**A STRUCTURAL ENGINEERING REPORT ON THE PROPOSED GARAGE
BLDG. ADDITION AT THE WESLEY BOALS LAKE PROPERTY**

Located in Aitkin County on Minnewawa Lake
at
47928 209TH. Place
McGregor, MN. 55760

Prepared for
Mr. Wesley Boals, the Owner

35840 Co. Rd. 238 Deer River, MN. Tel. 218/ 246-2396
Ref. Project C1915 Date: May 21, 2019

Per # 29-0-059106

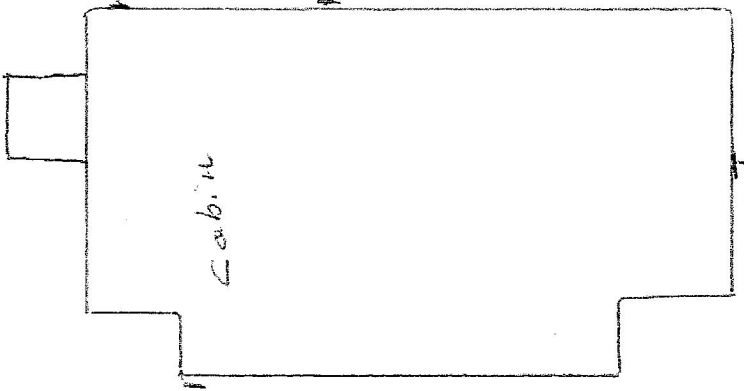
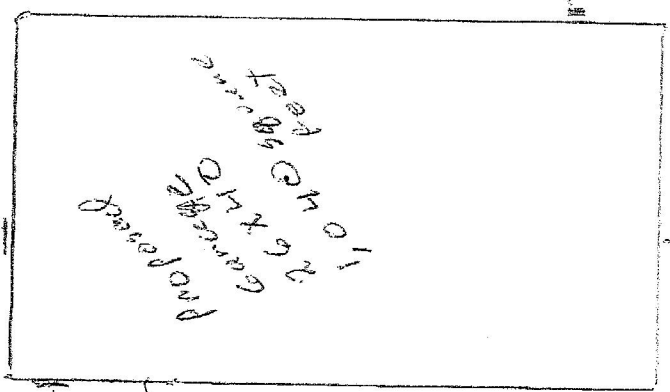
From the documents sent us and attached in Appendix A, it is apparent that the new garage addition will be only thirteen feet from the existing septic system drain field. **This is less than 20 feet clearance required by code from the sanitary drain field rock bed at the closest point.** Viewing the site plan of Appendix A, the septic tank is shown located thirteen feet south of the , garage building, well beyond the ten foot code limit.

The new garage building location is confined to the location shown on the site plan of Appendix A. As noted above, it will be encroaching onto the code's minimum requirement of 20 feet of space required from the rock bed. However, it is our opinion that the discharge flow through a properly working septic field, sized for the moderate loading of this lake shore residence as indicated on the Appendix A plans, should have no significant effect in reducing the bearing capacity of the proposed nearby shallow depth garage building foundations. **Based on these facts, we conclude the Site Plan, as presented by Mr. Boals, is acceptable from a Structural Engineer's evaluation.**

We reviewed the proposed garage building location regarding its influence on the existing waste disposal system (or vice versa) as given to us by Mr. Boals. We payed special attention to the proposed garage building location in regard to the septic system drain field. The garage building is to be located thirteen feet or so from the existing septic system drain field.

We conclude, the garage building and it's foundation addition may be located as shown on attached Appendix A, page A1 without significant adverse structural effects. Following construction, closeness of the drain lines of a properly functioning septic system in normal soils for this type of structure should have no significant detrimental effect on the foundation support for the reported building installation in accordance with the documents and email data sent us, and included in Appendix A
